**Economic and Social Council**Distr.: General
5 July 2013

Economic Commission for Europe**Inland Transport Committee****World Forum for Harmonization of Vehicle Regulations****Working Party on Brakes and Running Gear****Seventy-fifth session**

Motorcycle braking – Regulation No. 78**Proposal for amendments to Regulation No. 78 (Uniform provisions concerning the approval of vehicles of categories L₁, L₂, L₃, L₄ and L₅ with regard to braking)****Submitted by the expert from the International Motorcycles Manufacturers Association***

The text reproduced below was prepared by the expert from the International Motorcycles Manufacturer Association (IMMA) in order to introduce amendments to clarify the current text for the use of Combined Braking Systems (CBS). The modifications to the current text of the Regulation are marked in bold for new or strikethrough for deleted characters.

Conventional Brake System	Combined Brake System (CBS)	
Architecture A	Architecture B	Architecture C

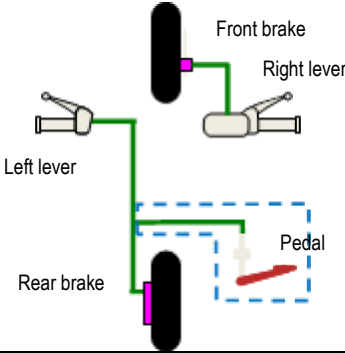
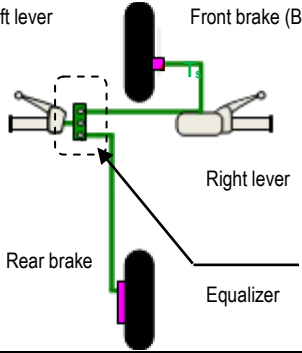
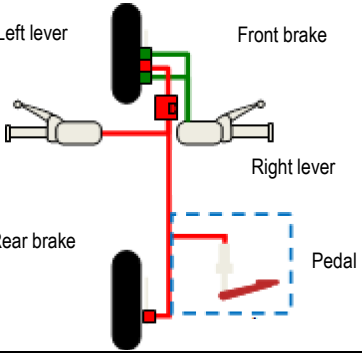
1. The current provision in UN Regulation No. 78 (§5.1.9), requiring that "two separate brake systems may only share a common brake if a failure in one system does not affect the performance of the other", limits the application of Combined Brake Systems (CBS).
2. Not all CBS architectures can meet this requirement although they will outperform conventional brake systems.
3. Not all CBS architectures were however considered at the time the original CBS requirements were drafted (in the 1980s) and it is therefore understood that GRRF did not intentionally exclude such systems by introducing this requirement.
4. Architecture B is an example of a CBS that shares a transmission (T_s) and a brake (B_s).

5. While a failure in e.g. the ‘front system’ (F_A) may affect the performance of the CBS, the rear system (operated by the left lever) will continue to be operational.

6. In order to ensure that, in case of a failure in one system, the performance of the other system still equals that of a conventional system, it is proposed to allow that two separate brake systems share a brake and/or a transmission, provided that the other system meets the single brake system performance requirements in case of a failure of such shared component(s). To that end, a failure test is proposed for CBS brake systems of Architecture B. IMMA is of the opinion that such a failure test requirement should ensure the acceptance of such a CBS in terms of demonstrated robustness and guaranteed minimum braking performance.

7. A failure test is not necessary for this type of CBS architecture because there are no shared components with the exception of a brake cylinder which is one of the components that are regarded to not be liable to breakage as described in 12.1. (b).

"5.1.9 In cases where two separate service brake systems are installed, the systems may share a common brake, ~~if a failure in one system does not affect the performance of the other~~ and a common transmission, if the requirements of Annex 3 paragraph 12 are met.

"12. CBS failure test
